## Change Notice for Subminiature Antistatic Process Sealed Keylocks Terminal Plating from Tin to Gold

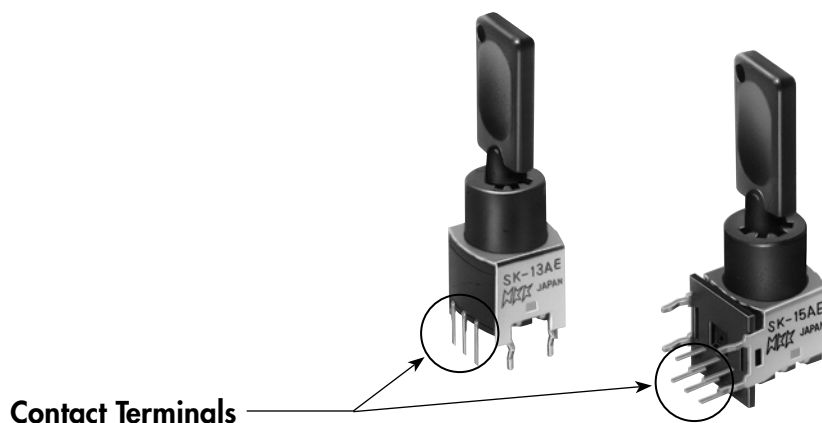
The entire SK Series with the 9mm diameter smooth bushing (E code) now has an improved surface finish to the contact terminals. This change includes all standard parts as well as related custom devices.

FROM	TO
Tin (Sn-Cu) Plating over Nickel (Ni) Plating	Gold Plating (Au) over Nickel (Ni)
